## Vacuum Switch Upgrade Procedure

Figure 1

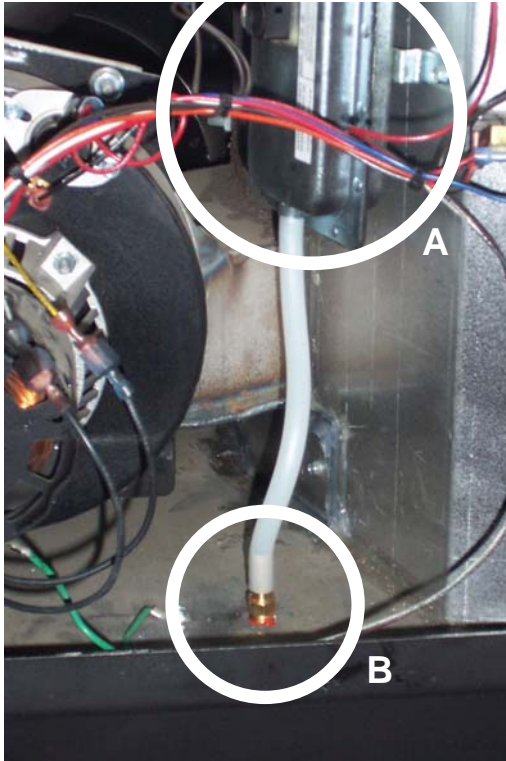
1. Remove side panel from the stove to reveal the vacuum switch (Fig 1, A).
2. Remove and discard 1/4" tubing attaching vacuum switch to 1/4" brass nipple installed on the auger shaft.
3. Drill and thread a 1/4" hole below the vacuum switch (it does not have to be directly beneath the switch).
4. Insert the new brass 3/8" nipple into this new hold with a light coating of silicon on the threads (Fig 1, B).
5. Measure, cut and insert a piece of 3/8" tubing from the bottom of the vacuum switch to the brass nipple below.
6. With a small amount of silicon, seal the old brass nipple opening as shown in Figure 2, C.
6. Replace side panel (Fig 3).
